# PRESERVATION COMMISSION

Tuesday February 9, 2021

To: Honorable Members of the Preservation Commission  
From: Cade W. Sterling, City Planner  
Subject: 1735 Asbury Avenue – 20PRES-0293  
Date: February 3, 2021

To: Honorable Members of the Preservation Commission  
From: Cade W. Sterling, City Planner  
Subject: 1206 Hinman Avenue – 21PRES-0012  
Date: February 3, 2021

### East Elevation Proposed

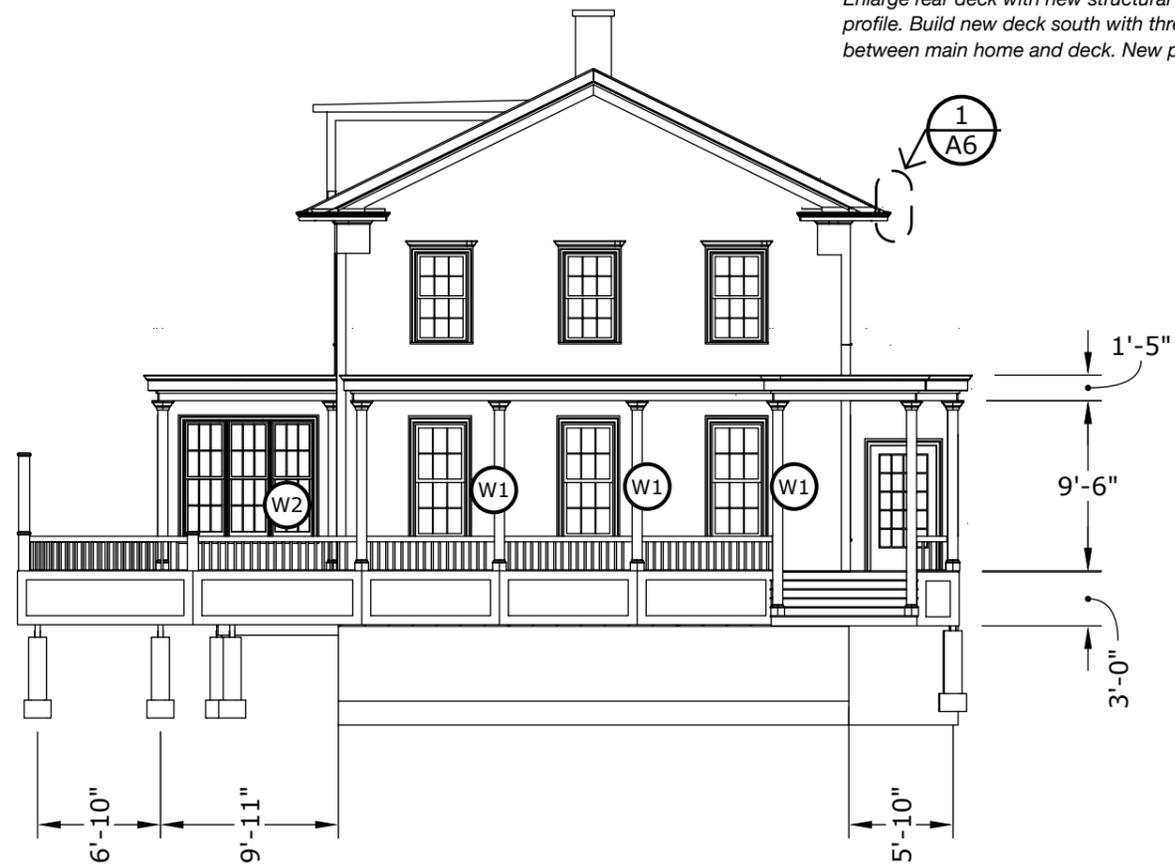
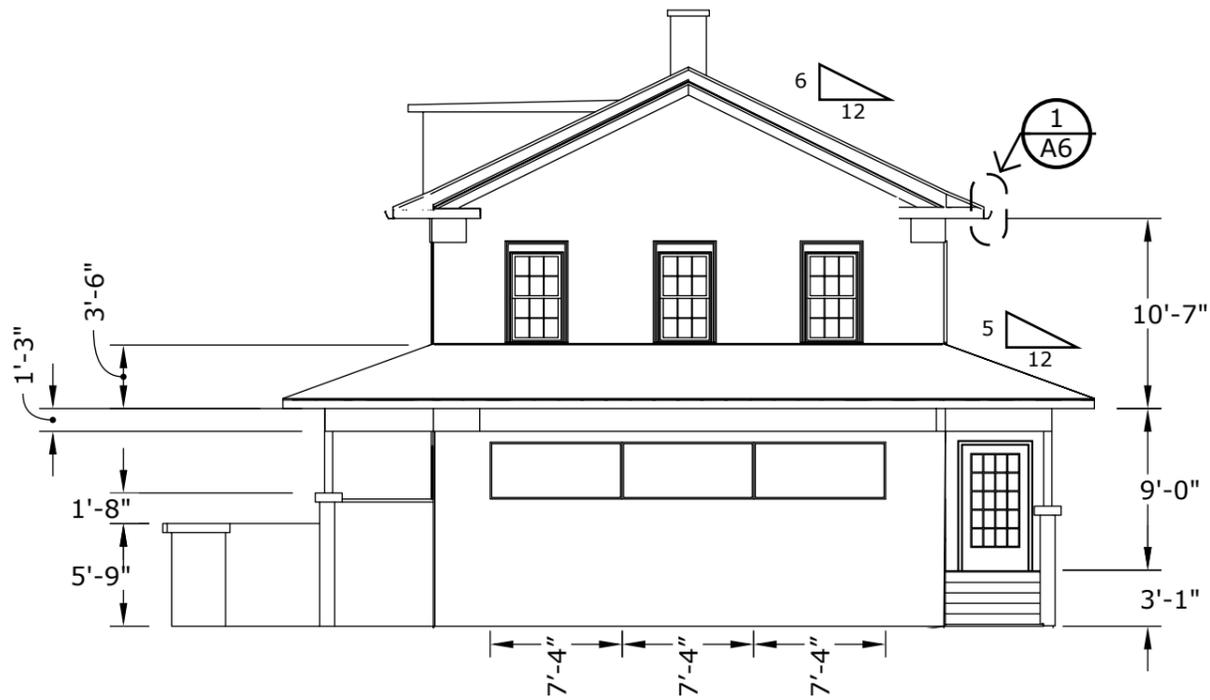
Commissioners had similar concerns related to the form and massing of the proposal, particularly the added horizontality of the front volume of the structure created through the detached three-season room to the south and the large roofed entry to the north. The added horizontality was thought to lack context with the rest of the forms on the block. Commissioners has additional concerns with the unnecessary ornamentation which had not existed previously on what was a vernacular rather than highly-styled Greek Revival structure, as well as the reorientation of the front entry stair and it no longer being identifiable from the street.

- East Elevation (Front-Volume)  
The proposed east elevation has been revised significantly. The revised proposal re-orientes the front-stair with front entry easily identifiable and a contextual relationship between the home and the street/sidewalk. The roof form has been changed from hipped to flat and raised slightly. The three-season room has been attached to the principle structure, and the covered front porch terminates at the original structures south elevation with a wraparound open porch continuing along the south elevation.

The flat roof form is sympathetic to the original structure -- removing the unnecessary replication of the non-contributing circa 1950s alterations. The revisions reduce the previous horizontality in favor of more appropriate and contextual proportions. The three-season room, although near the front-façade (setback one foot), is adequately subordinate to the original structure, particularly due to the covered front porch terminating where the three-season room begins – creating proper authenticity (ability to identify it as an addition). In summary, the alterations proposed provide for identification of the original structure where the previous proposal and non-contributing circa 1950s alterations had obscured it. The design vocabulary is adequately vernacular and the unnecessary ornamentation except for the enlarged frieze board, have been largely removed. Re-orientation of the front-stair to front the street is appropriate although the extended covered stair “portico” unnecessarily complicates the balance of the front-porch and creates awkward asymmetric porch column placement.
